Revised:
CHANGE ORDER
10/01/2018
REV.FINAL
10/15/2018

Plan No:
R.4091-A
Home Buyer:
CURTIS RESIDENCE
121 Red Hawk Road
Huntsville, Texas 77340
Job # 19-10-020

Sheet No.
A-1
Floor Plan

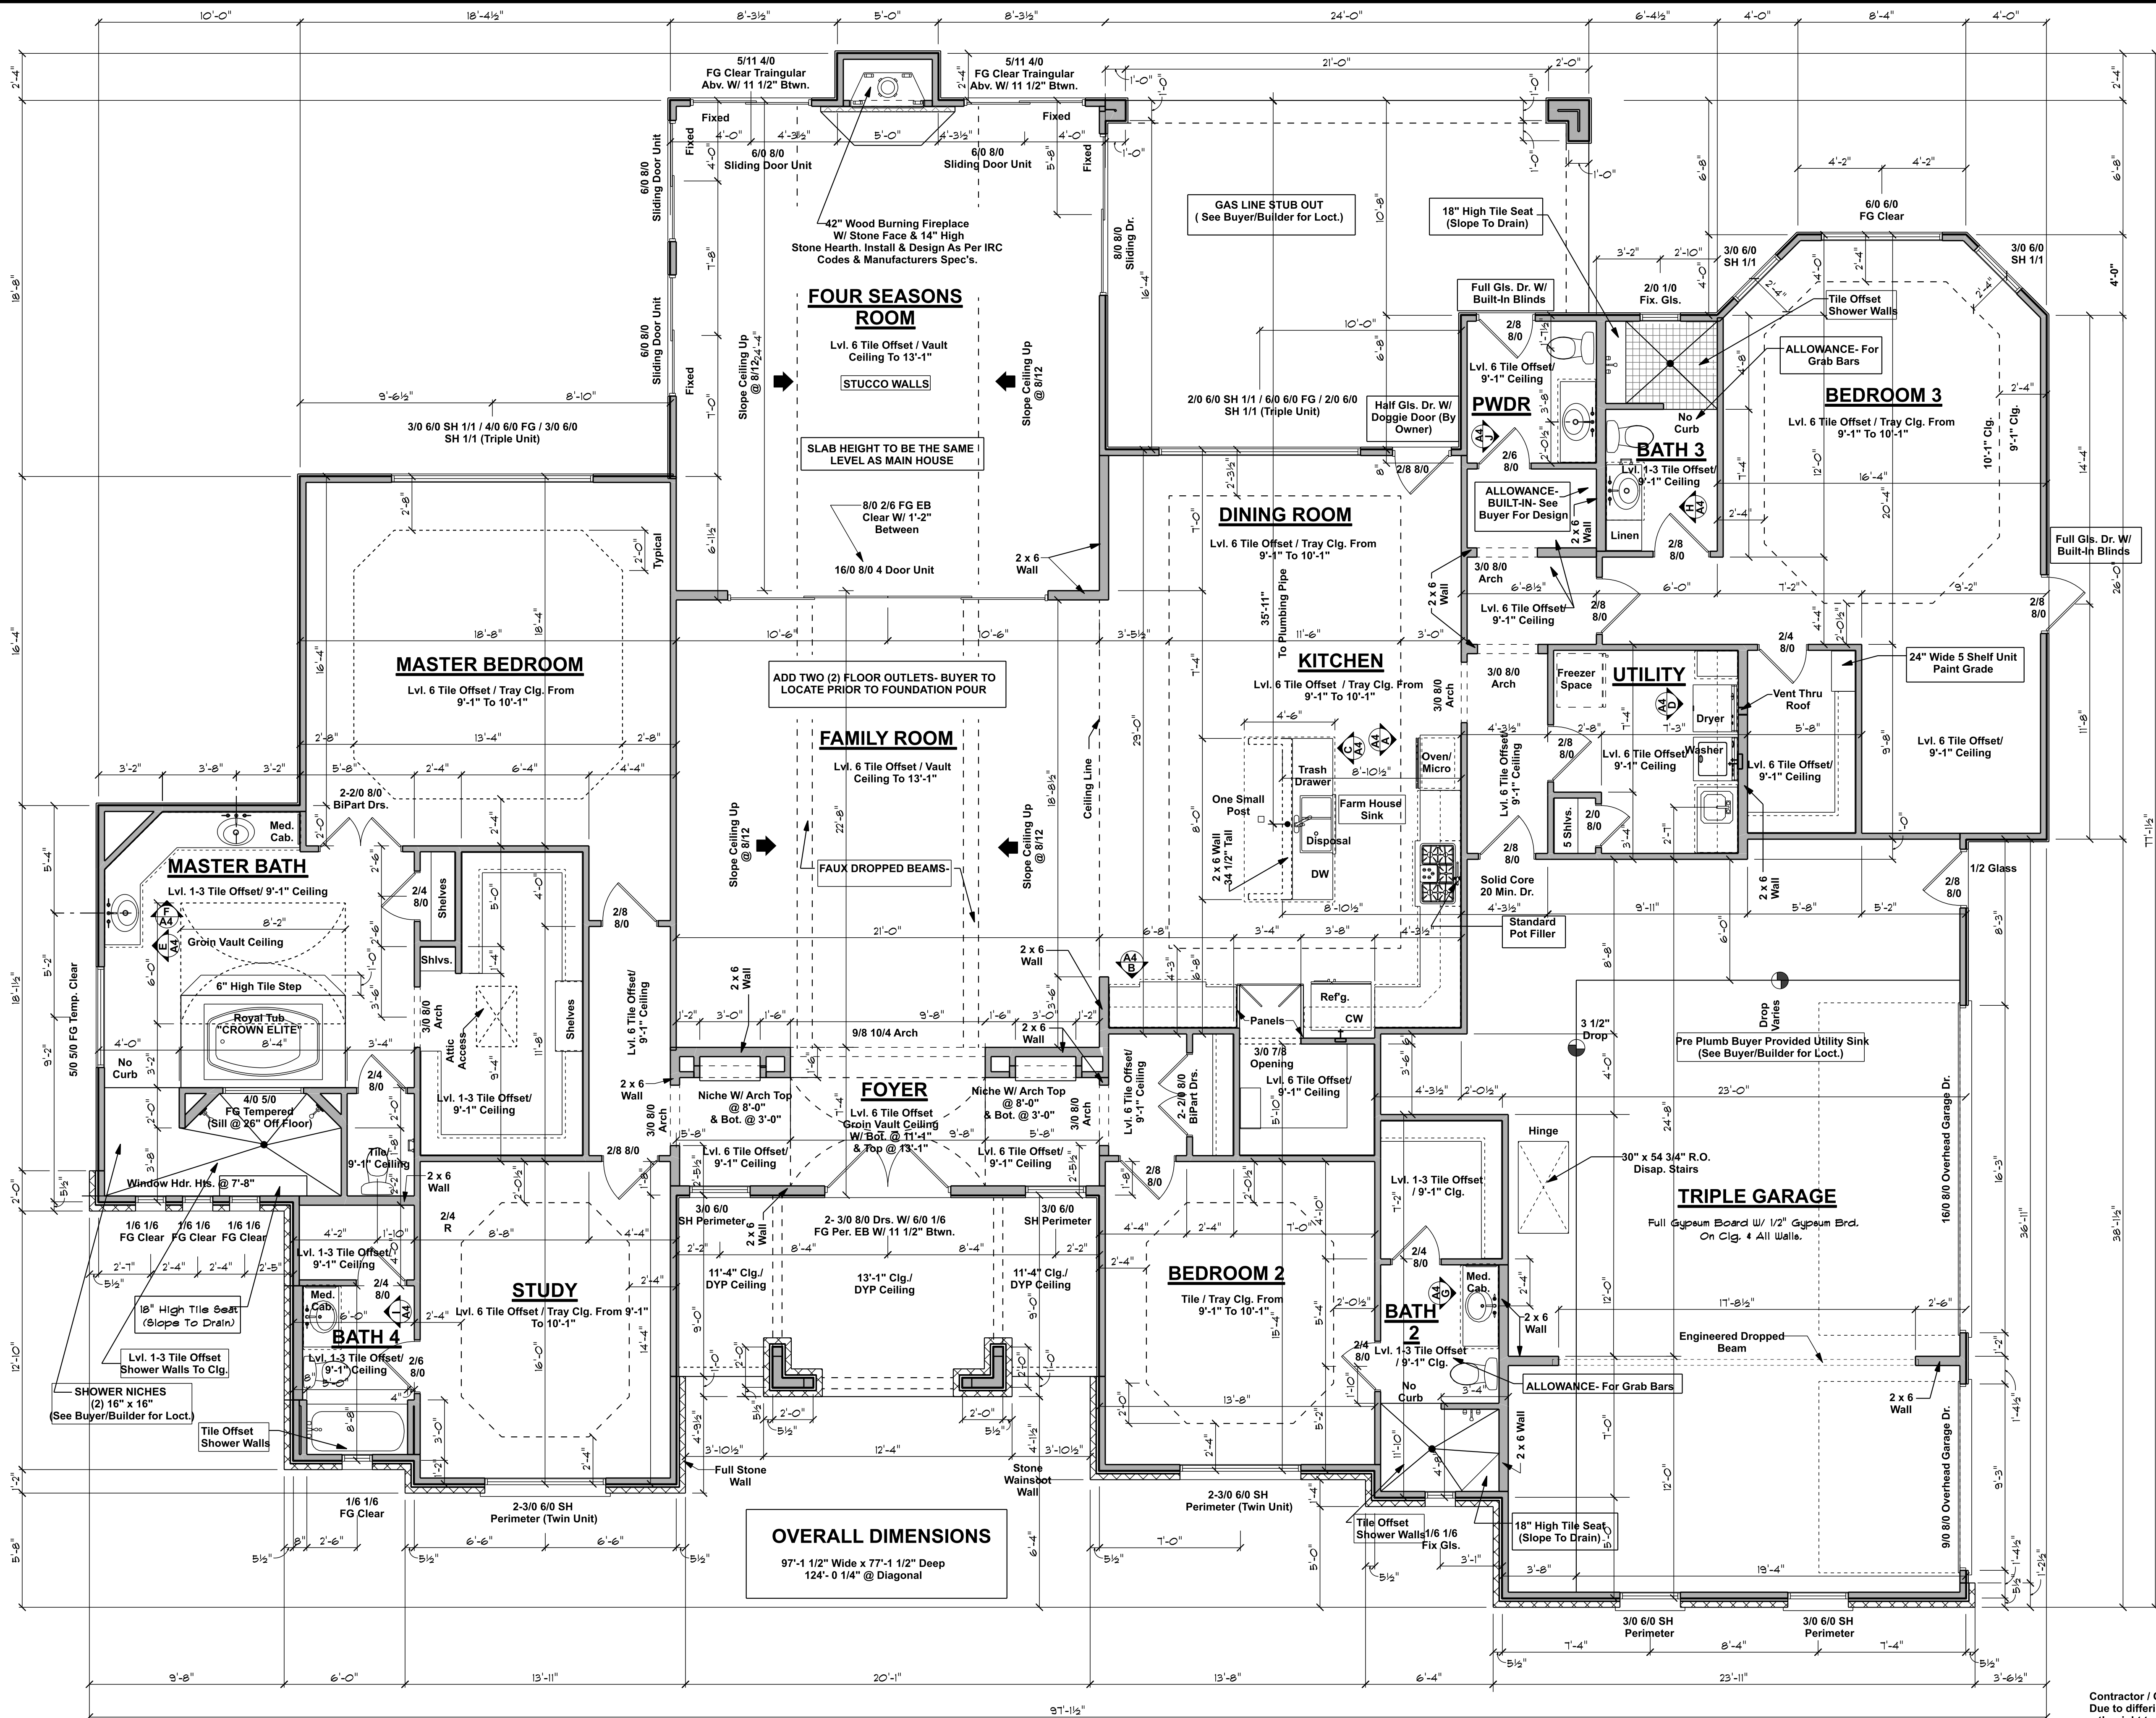
- * Eggshell Paint Throughout Home-
- Semi-Gloss Paint In All Bathrooms

- * Painted Grey Island w/Raised End and Front Panels.
- * Upgrade Quartz Countertops.
- * Soft Close Drawers & Doors.
- * Bump Out Cabinet @ Stove.
- * Add Electric for Second Built-In Oven Underneath Cooktop.
- * Upgrades Above Cooktop & Pantry.
- (See Buyer/Builder for Design)
- * Hardware for Drawers & Doors.
- * LED Strip Undercounter Light to One Switch.
- * Lazav Susan @ Corner Cabinet.
- * Bump Out Middle Cabinet Next to Fridge.

- * Kitchen, Master Bath, Utility, Bath 2, 3 & 4.
- Quartz (See Buyer/Builder for Color Selection)

- * Soft Close Drawers & Doors on All Cabinetry

- * Full Gutters

*Insulation Bib In Exterior Walls R-15
